**V2500-A1/A5 SERIES PROPULSION SYSTEMS SERVICE BULLETIN**

This document transmits the Initial Issue of Service Bulletin EV2500-79-0080

OIL - AIR COOLED OIL COOLER MODULATING VALVE - INTRODUCTION OF AN AIR MODULATING VALVE WITH REVISED ACTUATOR END CAP RETAINING WASHERS

FLIGHT CONTROLS - AIR MODULATING VALVE TY1558 - THICKER WASHER ADDED  
MODIFICATION L1558-10

Sequence to Remove Bolts  
Figure 1

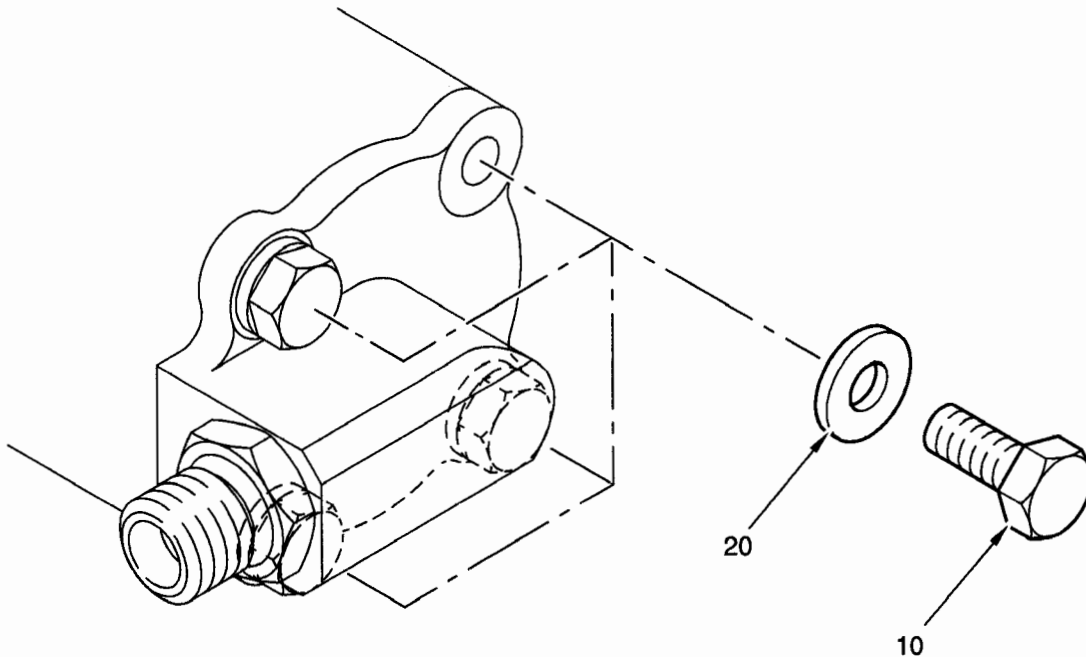
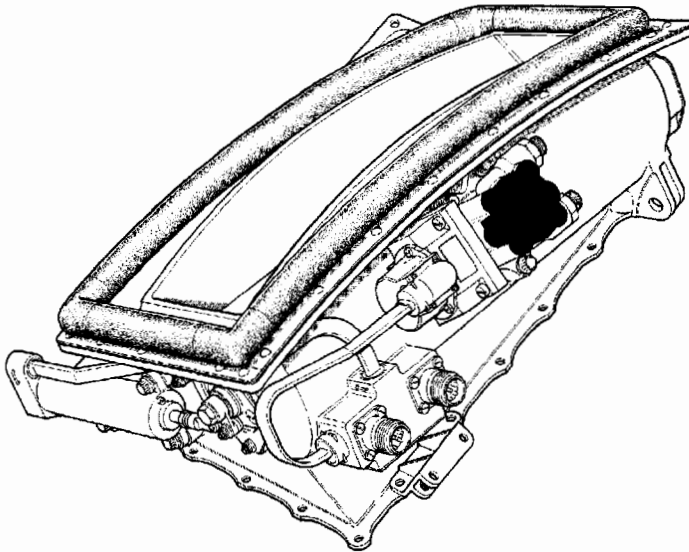
(1) Measure the torque of the bolt and install a new washer at position A (Refer to Fig 1).

- (2) Measure the torque of the bolt and install a new washer at position B (Refer to Fig 1).
  - (a) Use the torque wrench to measure the required torque needed to release the bolt.
  - (b) Check this result with the torque values listed in Table 1. Make sure the torque value is permitted and the unit is serviceable. If the unit is unserviceable, then return the unit to TRW Aeronautical Systems Lucas Aerospace.
  - (c) Remove and retain the bolt (10, Fig 2) from the Actuator End Cap.
  - (d) Remove and discard the washer (20, Fig 2) from the Actuator End Cap.
  - (e) Install the new washer (20, Fig 2) on the Actuator End Cap.
  - (f) Re-install the bolt (10, Fig 2) into the Actuator End Cap.
  - (g) Torque tighten the bolt (10, Fig 2) between 2,82 and 3,39 Nm (24.96 and 30.00 lbf in).

- (3) Measure the torque of the bolt and install a new washer at position C (Refer to Fig 1).
  - (a) Use the torque wrench to measure the required torque needed to release the bolt.
  - (b) Check this result with the torque values listed in Table 1. Make sure the torque value is permitted and the unit is serviceable. If the unit is unserviceable, then return the unit to TRW Aeronautical Systems Lucas Aerospace.
  - (c) Remove and retain the bolt (10, Fig 2) from the Actuator End Cap.
  - (d) Remove and discard the washer (20, Fig 2) from the Actuator End Cap.
  - (e) Install the new washer (20, Fig 2) on the Actuator End Cap.
  - (f) Re-install the bolt (10, Fig 2) into the Actuator End Cap.
  - (g) Torque tighten the bolt (10, Fig 2) between 2,82 and 3,39 Nm (24.96 and 30.00 lbf in).

- (4) Measure the torque of the bolt and install a new washer at position D (Refer to Fig 1).
  - (a) Use the torque wrench to measure the required torque needed to release the bolt.

(a) Use the torque wrench to measure the required torque needed to release the bolt.

(b) Check this result with the torque values listed in Table 1. Make sure the torque value is permitted and the unit is serviceable. If the unit is unserviceable, then return the unit to TRW Aeronautical Systems Lucas Aerospace.

Torque Value	Action to be taken
Upto: 3,62 Nm (32.04 lbf in)	This torque value is permitted. Continue with the accomplishment instructions in this Service Bulletin.
From: 3,62 to 6,21 Nm (32.04 to 54.96 lbf in)	Visually inspect the bottom of the bolt hole. Check it for signs of polished surfaces. <ul style="list-style-type: none"> <li>- Signs of polishing. This unit is unserviceable, return the unit to TRW Aeronautical Systems Lucas Aerospace (Ref. NOTE 1).</li> <li>- No signs of polishing. Continue with the accomplishment instructions in this Service Bulletin.</li> </ul>
Over: 6,21 Nm (54.96 lbf in)	This torque value is not permitted. This unit is unserviceable, return the unit to TRW Aeronautical Systems Lucas Aerospace (Ref. NOTE 1).
